Preliminary & Final Drainage Report
for
Rex Road
through
Falcon Regional Park

MERIDIAN RANCH
A GOLF & RECREATIONAL COMMUNITY

EL PASO COUNTY, COLORADO

PCD Project No. CDR236

FIGURE 6

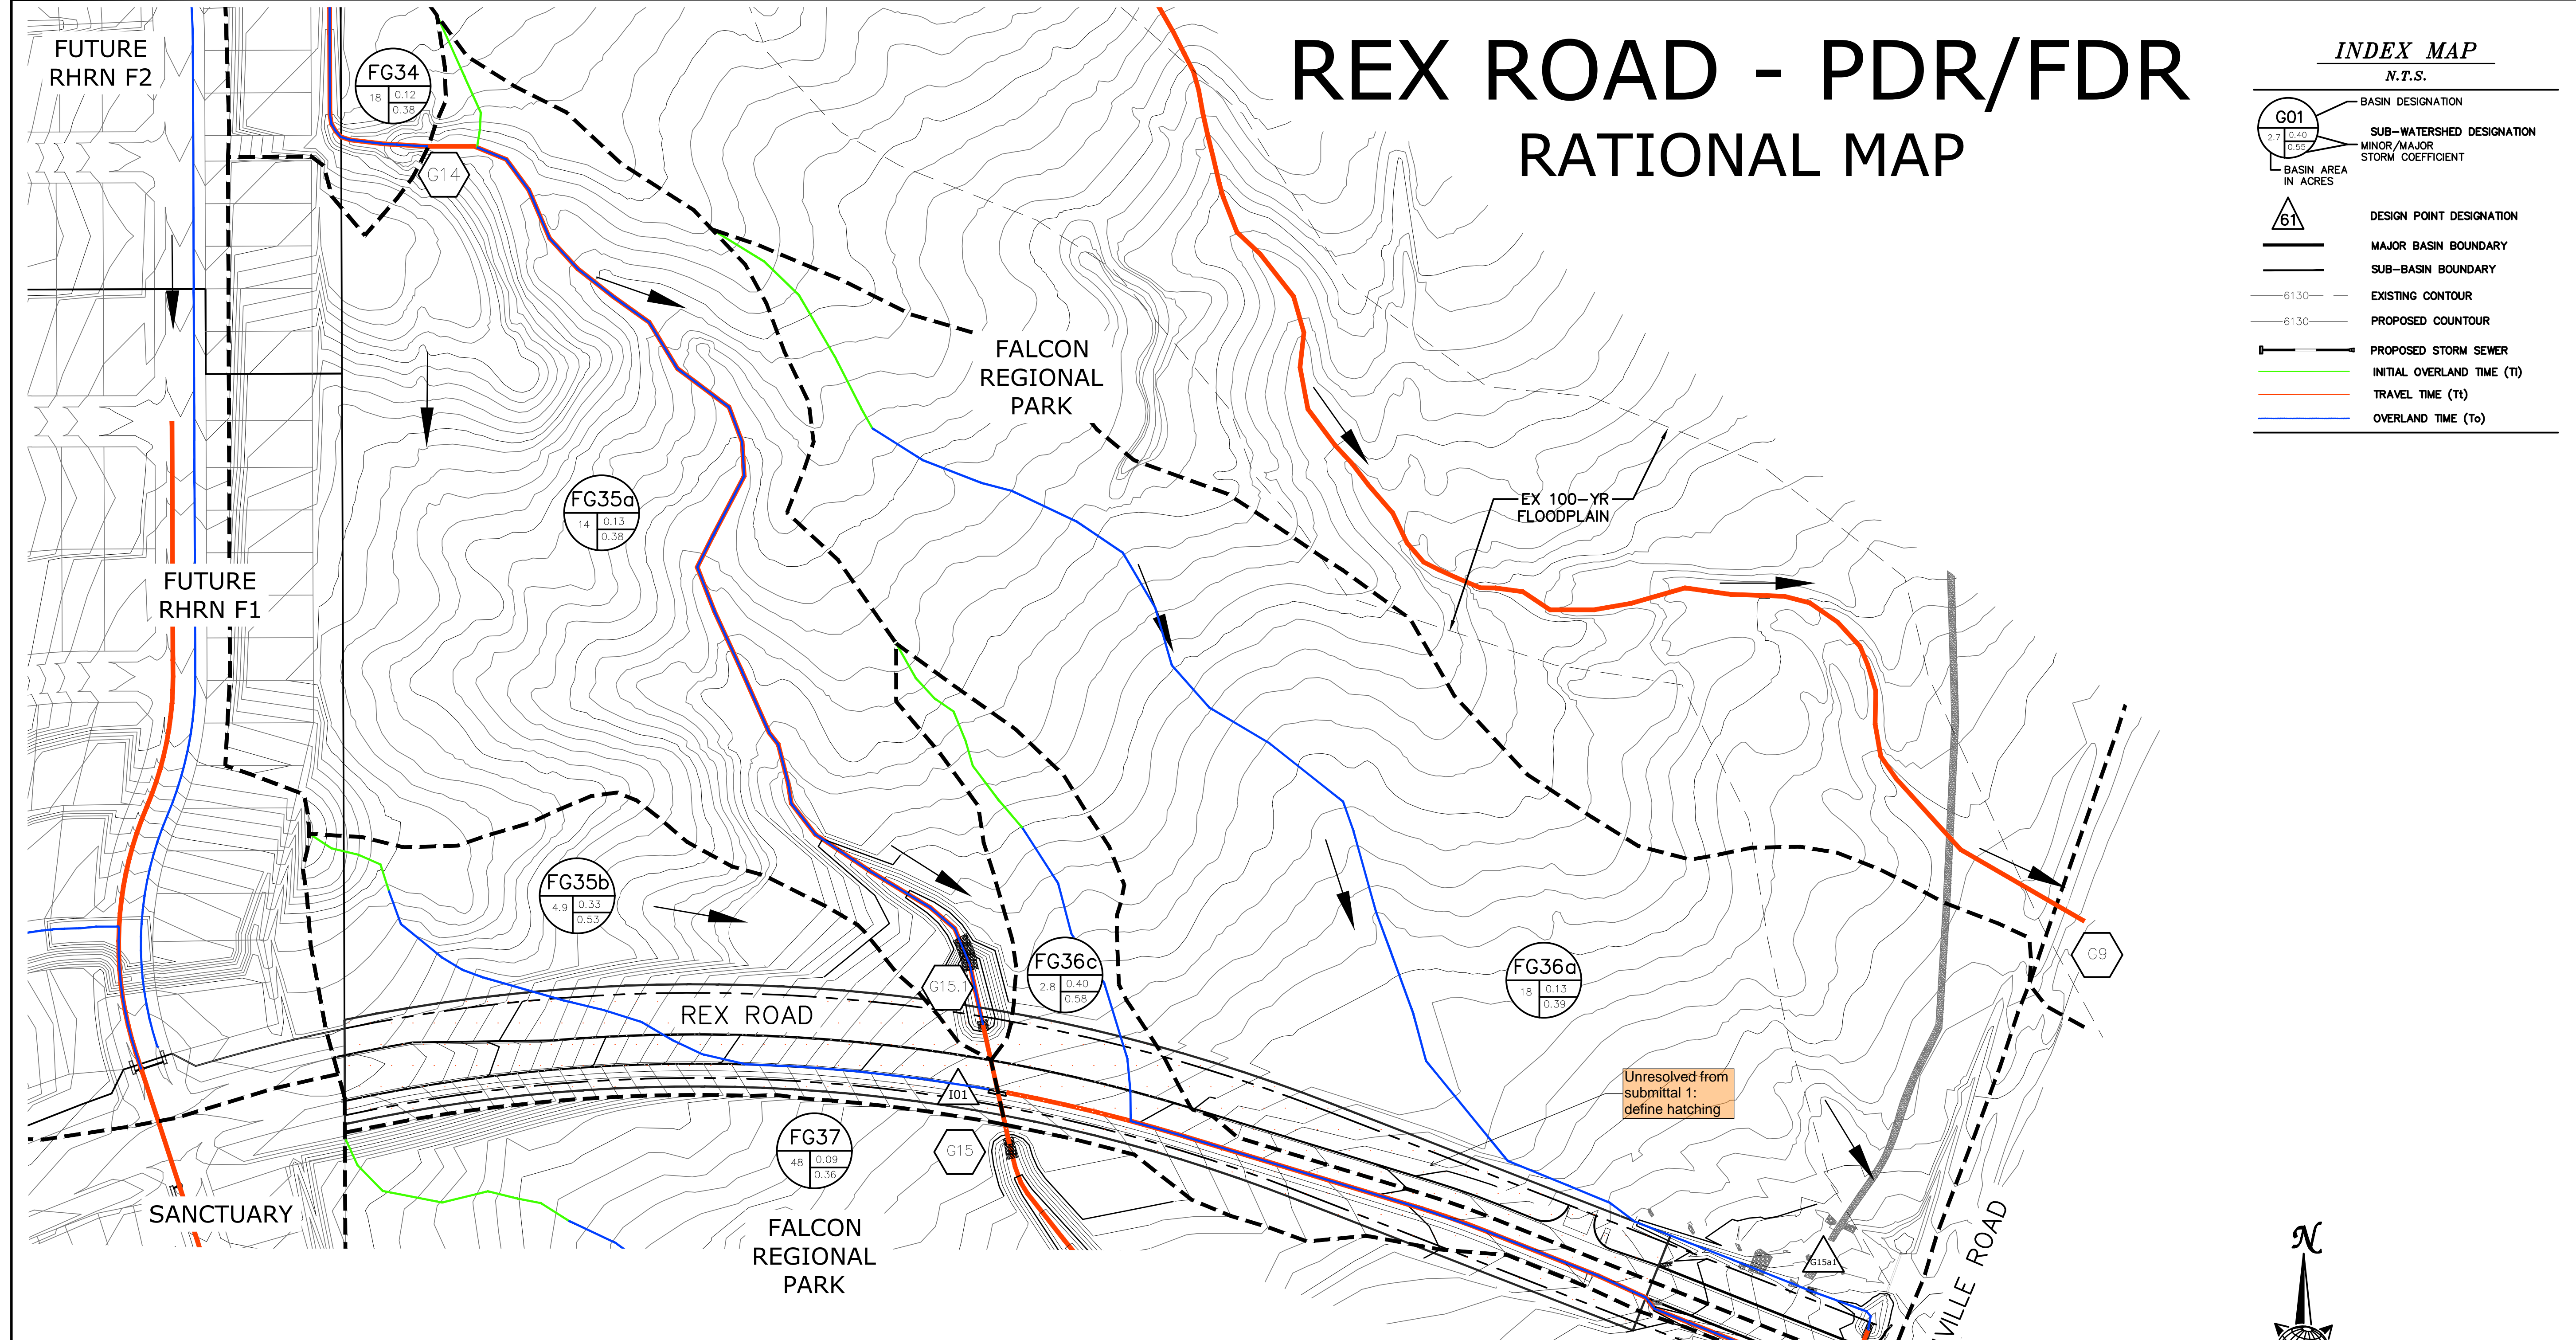
Unresolved from submittal 1: define hatching

FIGURE 7

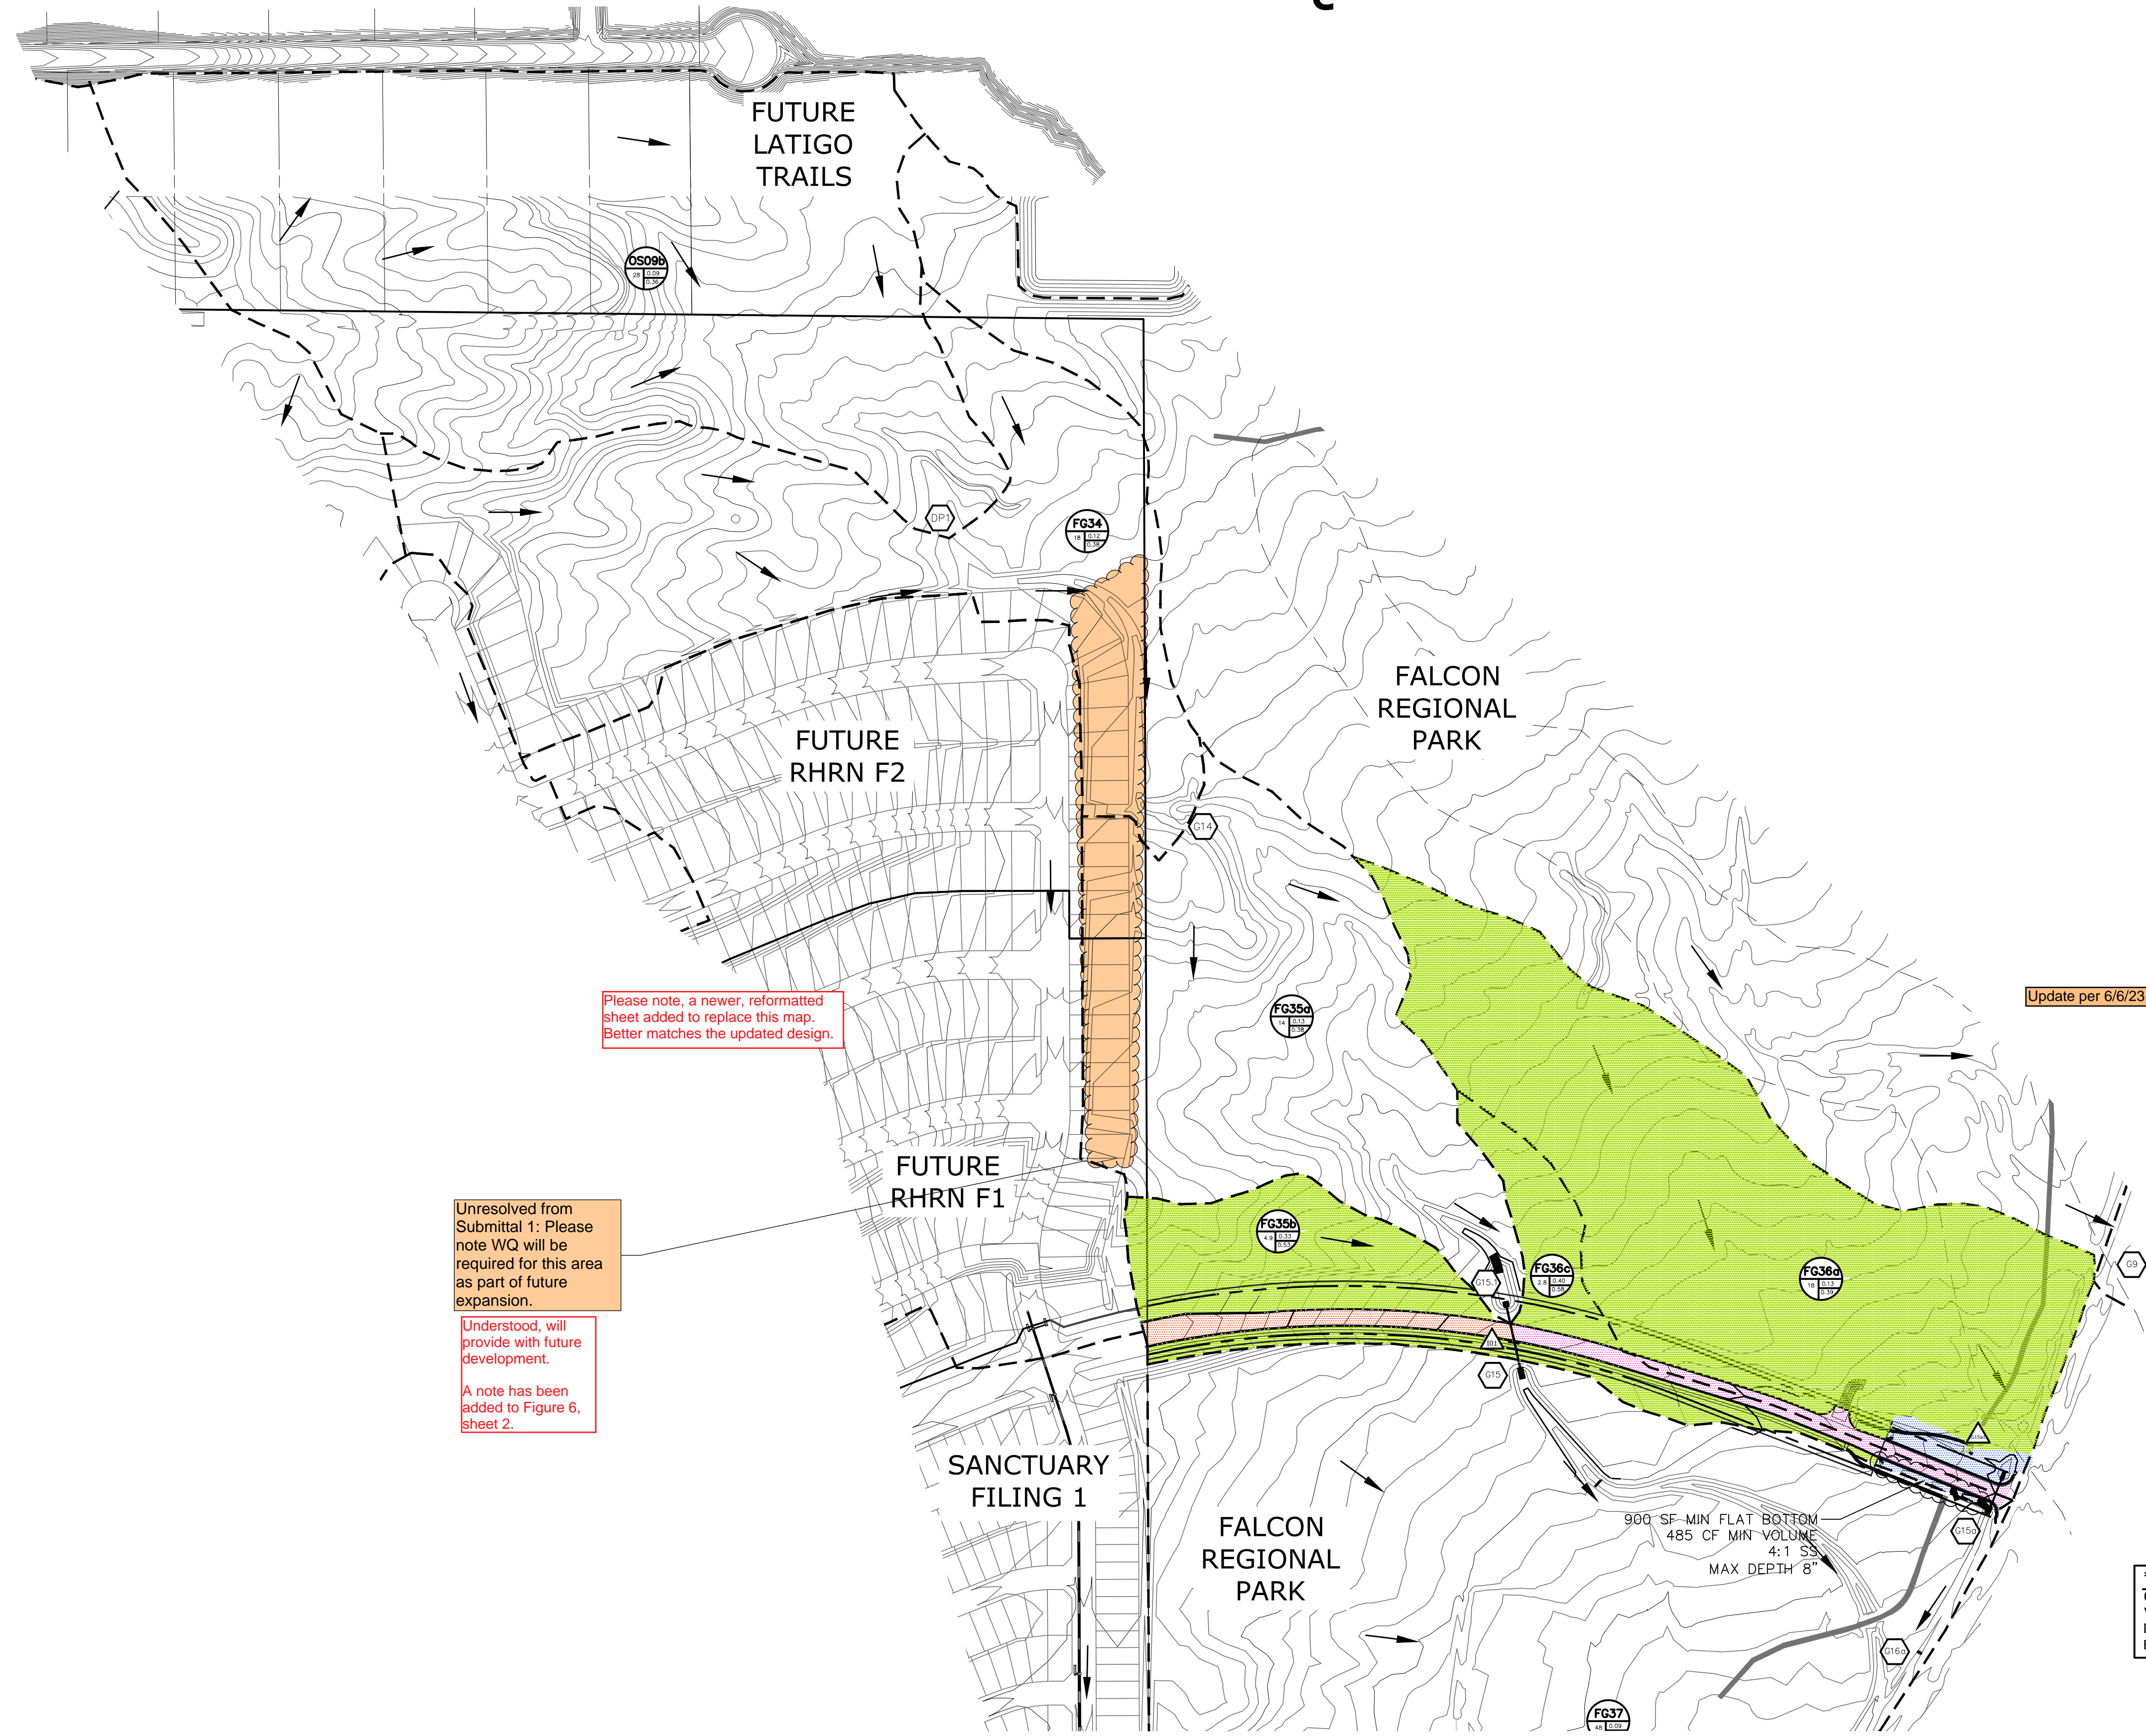
Unresolved from Submittal 1: Please note WQ will be required for this area as part of future expansion.

Update per 6/6/23 WQ coordination meeting

Please note, a newer, reformatted sheet added to replace this map. Better matches the updated design.

Understood, will provide with future development.

A note has been added to Figure 6, sheet 2.
